ROOSEVELT AVE SELF-STORAGE SITE PLAN APPLICATION #06-19

STAFF REPORT July 24, 2019

SITE: 23 Roosevelt Avenue – Map 191 Lots 115 & 116

PURPOSE OF PLANS: to construct a 3-story storage facility and associated parking.

Conceptual North Elevation

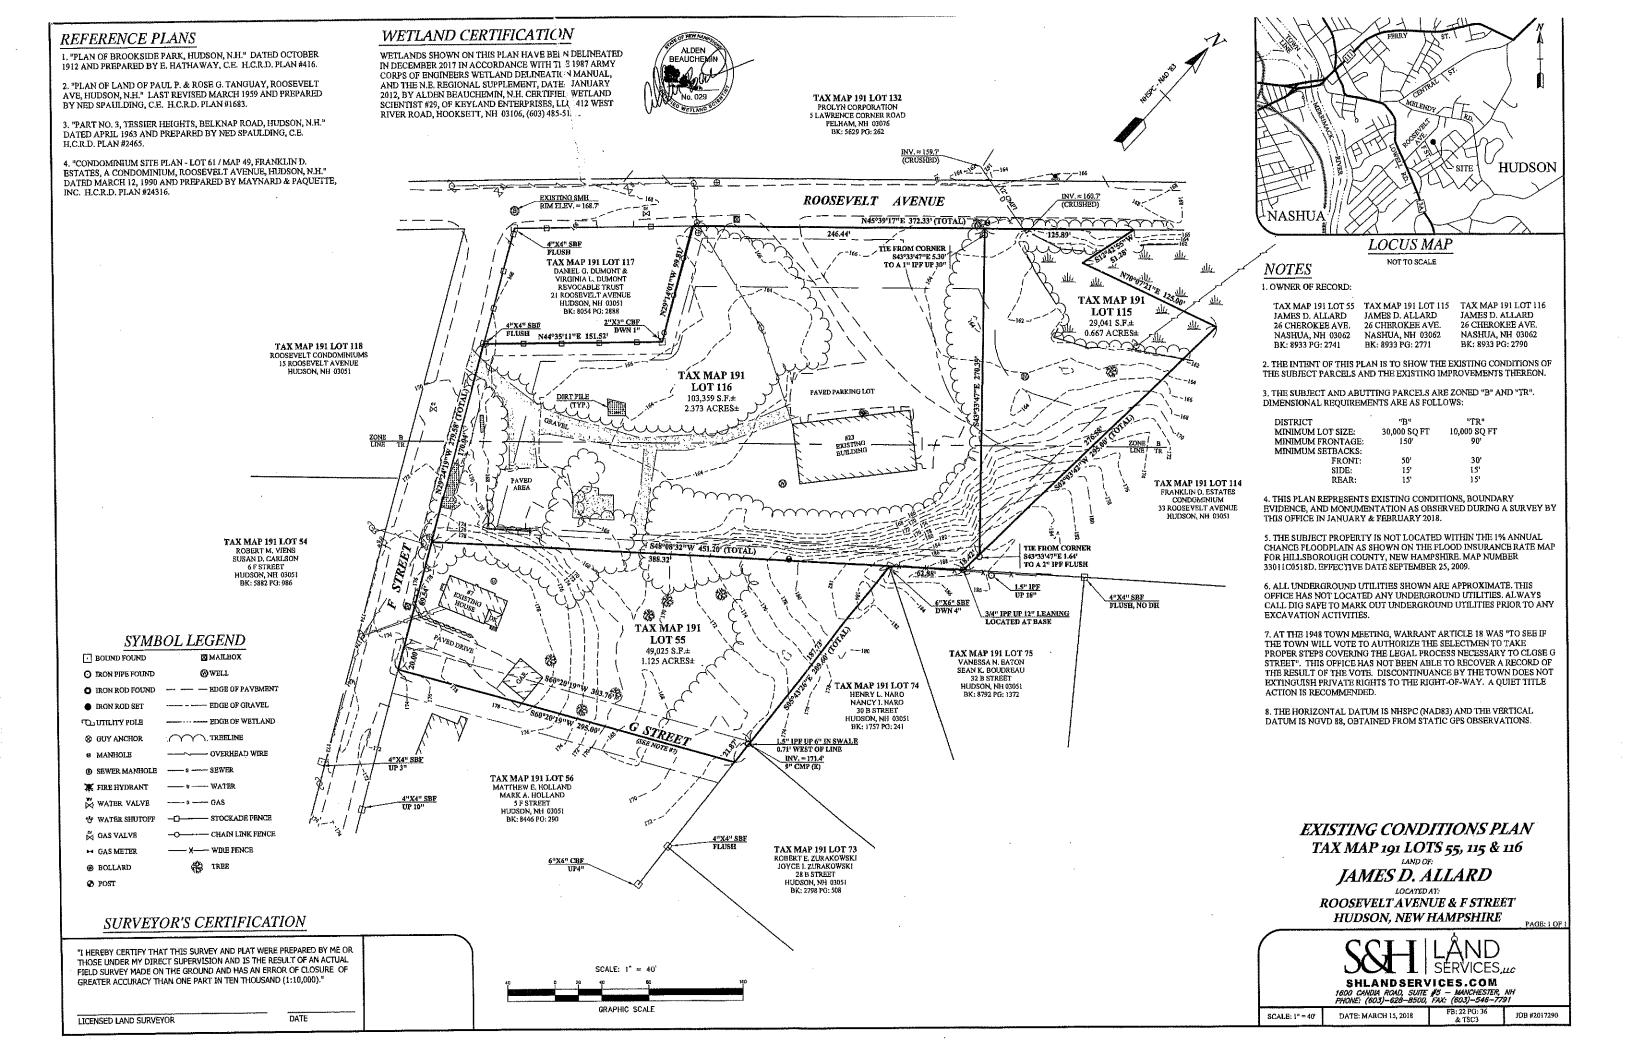
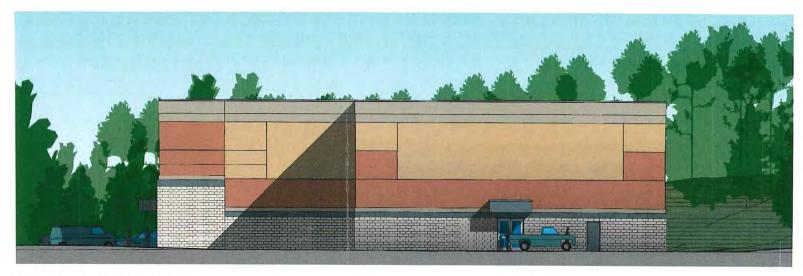
As noted in Fuss & O'Neill's comments (*Attachment F*), the elevations do not match the site plan, specifically in regards to building entrances. The applicant should revise accordingly.

The plan set states that the permitted building height per Zoning is 50-feet which is incorrect. The maximum building height is 38-feet. The building height should be noted on the elevations

While not required, it is recommended that the applicant show signage they may intend to install on the building.

It is recommended that the applicant provide the Planning Board with additional detail on the materials and colors to be used on the exterior of the building.
